# Access Compliance Report

## Public Rights-of-Way

### (Pedestrian Signals)

Intersection ID: N/A	Main Street:	Cross Street: N/A	Location: N/A
ADA ID: D30C4EEAC727	Signal Type: One Push Button-Non APS	Overall Compliance: No	Severity Score: BTN 1: N/A BTN 2: N/A No BTN: N/A
Codes/Mitigation Info/Possible Solution		Field Measurements/Component Compliance

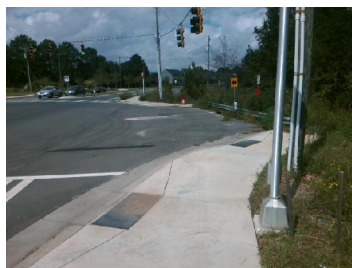
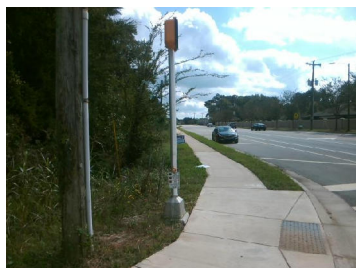
PROW/ADA: TMUTCD 4e.08, R104.2, R209.1

Compliance	Description	Data	Compliance	Description	Data
	Button Count	Button1	N/A	Distant to Additional Button (in)	N/A
	Additional Button Present?	No		Additional Button ID	N/A
N/A	Signal Buttons Required?	N/A	N/A	Additional Ped Posts Required	N/A
	How Many Ped Street Xings?	2		Located In An Island/Median?	No
N/A	B 1 Sign Present?	Yes	N/A	B 2 Sign Present?	N/A
Yes	B 1 Sign Purpose?	Yes	N/A	B 2 Sign Purpose?	N/A
Yes	B 1 Sign Lettering & Contrast?	Yes	N/A	B 2 Sign Lettering & Contrast?	N/A
Yes	B 1 Parallel To XWalk?	Yes	N/A	B 2 Parallel To XWalk?	N/A
Yes	B 1 PAR to Button?	Yes	N/A	B 2 PAR to Button?	N/A
Yes	B 1 PAR to XWalk?	Yes	N/A	B 2 PAR to XWalk?	N/A
Yes	B 1 Clear Floor Space?	Yes	N/A	B 2 Clear Floor Space?	N/A
N/A	B 1 FWD Approach?	No	N/A	B 2 FWD Approach?	N/A
N/A	B 1 FWD Approach Constrained?	N/A	N/A	B 2 FWD Approach Constrained?	N/A
N/A	B 1 FWD Approach Reach (in)	N/A	N/A	B 2 FWD Approach Reach (in)	N/A

N/A	B 1 FWD Approach Width (in)	N/A	N/A	B 2 FWD Approach Width (in)	N/A
N/A	B 1 FWD Approach Obstruction?	N/A	N/A	B 2 FWD Approach Obstruction?	N/A
N/A	B 1 FWD Approach Obstruction Dist (in)	N/A	N/A	B 2 FWD Approach ObstructionDist (in)	N/A
N/A	B 1 PARA Approach?	Yes	N/A	B 2 PARA Approach?	N/A
N/A	B 1 PARA Approach Constrained?	No	N/A	B 2 PARA Approach Constrained?	N/A
Yes	B 1 PARA Approach Reach (in)	9.0	N/A	B 2 PARA Approach Reach (in)	N/A
N/A	B 1 PARA Approach Width (in)	N/A	N/A	B 2 PARA Approach Width (in)	N/A
N/A	B 1 PARA Approach Obstruction?	Yes	N/A	B 2 PARA Approach Obstruction?	N/A
N/A	B 1 PARA Approach Obstruction Dist (in)	2.0	N/A	B 2 PARA Approach ObstructionDist (in)	N/A
Yes	B 1 Clear Floor Space Slope (%)	2.3	N/A	B 2 Clear Floor Space Slope (%)	N/A
Yes	B 1 Clear Floor Space XSlope (%)	1.9	N/A	B 2 Clear Floor Space XSlope (%)	N/A
N/A	B 1 PAR Slope (%)	8.1	N/A	B 2 PAR Slope (%)	N/A
Yes	B 1 Height (in)	39.0	N/A	B 2 Height (in)	N/A

Yes	B 1 Pressure (#)	2.0	N/A	B 2 Pressure (#)	N/A
No	B 1 Closed Fist Operation?	No	N/A	B 2 Closed Fist Operation?	N/A

Yes	B 1 Clear Xing Direction?	ClearlyMarked	N/A	B 2 Clear Xing Direction?	N/A
	B 1 Crossing Direction	To SW		B 2 Crossing Direction	N/A
Yes	B 1 DistanceTo XWalk (in)	0.0	N/A	B 2 DistanceTo XWalk (in)	N/A
No	B 1 DistanceTo Curb (in)	96.0	N/A	B 2 DistanceTo Curb (in)	N/A
Yes	B 1 Diameter (in)	2.0	N/A	B 2 Diameter (in)	N/A

Possible Solutions: Replace Signal Push Button With APS Button on New Post. Remove & Relocate Sign.
